WSDOT SR520 PROGRAM Pontoon Construction Project Expert Panel Report, Phase 2

Submitted to WSDOT by the Expert Panel February 18th 2013

Figure 1, Crack Maps for Pontoon V

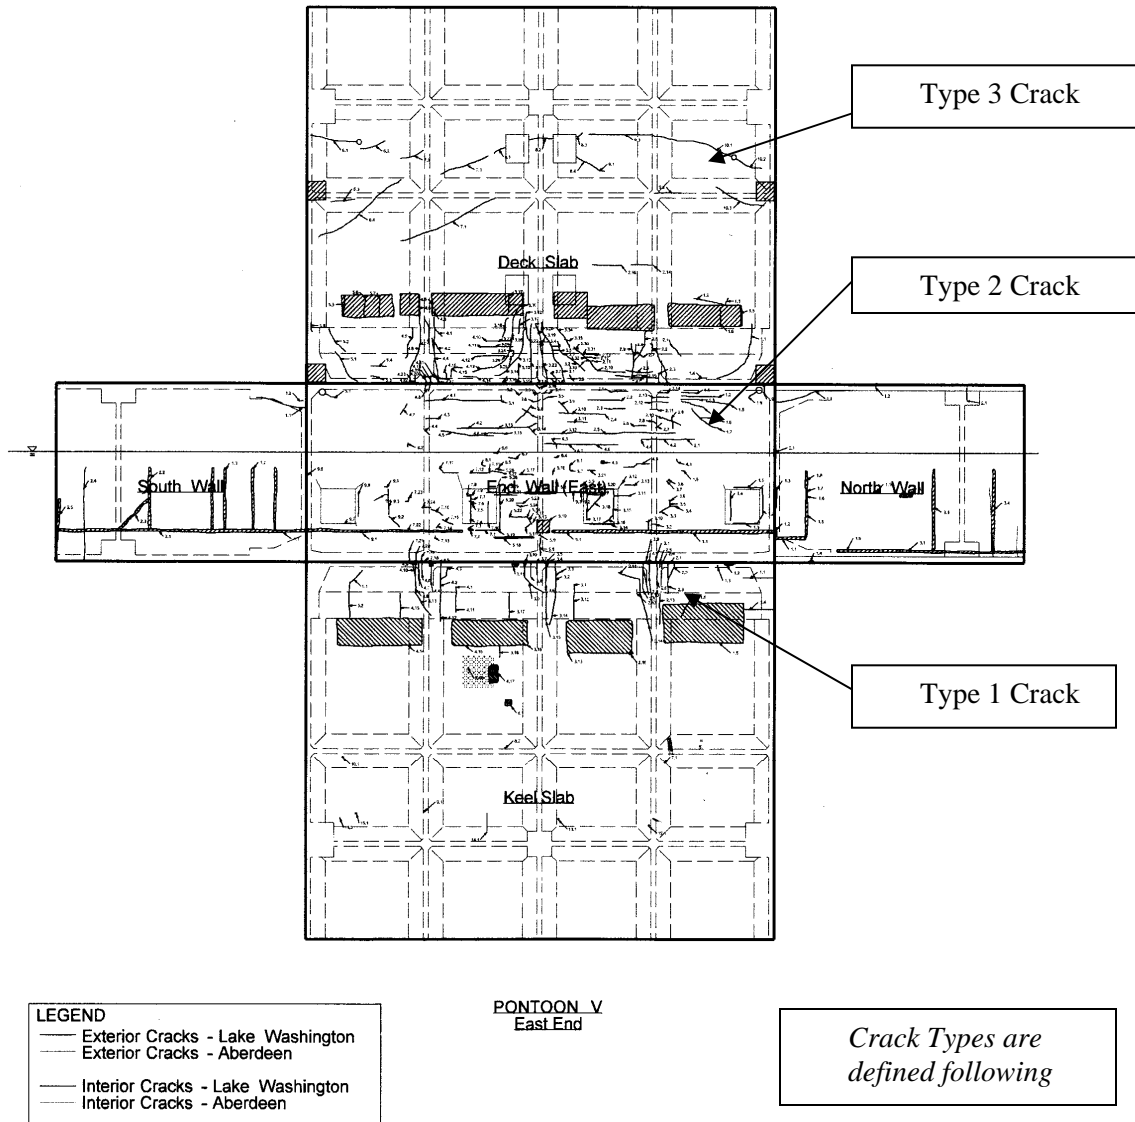
1. Keel Slab Cracks: (Crack Type 1 in figure). The most serious cracks are keel slab cracks that extend in the longitudinal direction of the pontoon. Similar longitudinal cracks are located sometimes in the exterior walls and frequently in the deck slab of the pontoon. Watertightness is of less concern for those wall and deck slab cracks than the corresponding keel slab cracks. The effects of the longitudinal post-tensioning are the same for all these cracks. Longitudinal cracks may be present due to the spalling stresses between tendon groups, bursting stresses in front of a tendon anchorage, and “shear lag” effects associated with the flow of prestressing forces into the precast interior walls . These cracks would be exacerbated by hydraulic loads in both service and extreme loading conditions.

2. End Wall Cracks, pontoons A & W: (Crack Type 2 in figure). There is no bolt-beam inside the end walls for these two pontoons (the bolt-beams are located in the middle of the side walls). Existing cracks in the body of the wall will be exacerbated by both service and extreme hydraulic loads. They will have withstood the hydraulic loads associated with towing which may have further opened and/or extended existing cracks. These walls are only subject to hydraulic loads perpendicular to the plane of the wall in service. It should be a relatively simple task to estimate crack width under service and extreme loads and carry out appropriate repairs.

3. End Wall Cracks, pontoons T through V (Crack Type 2 in figure) Existing cracks in the body of the wall inside the bolt-beam will be exacerbated by both service and extreme hydraulic loading conditions. pontoons T, U, and V have withstood the hydraulic loads associated with towing which may have further opened and/or extended the existing cracks. Once the pontoons are connected these end walls are no longer subject to load except for the pressure due to grouting of the joints. The panel does not believe that these end wall cracks are likely to be a major cause for concern for regarding service life and maintenance.

4. Longitudinal Wall and Deck Slab Transverse Cracks (Crack Type 3 in figure): These cracks should close upon application of the longitudinal post-tensioning. The only question pertains to the width under extreme loads and the potential leakage amounts. The BSO estimation of the potential crack widths, due to longitudinal flexure of the pontoons, was based on a strain compatibility analysis. The results from such an analysis were compared with the service and extreme moment demands. Shear cracking due to torsion and vertical shear was predicted and is coincident with flexural demands. The effect of the longitudinal prestress in limiting such cracks and on the resulting slope of the cracks was neglected. This is conservative.
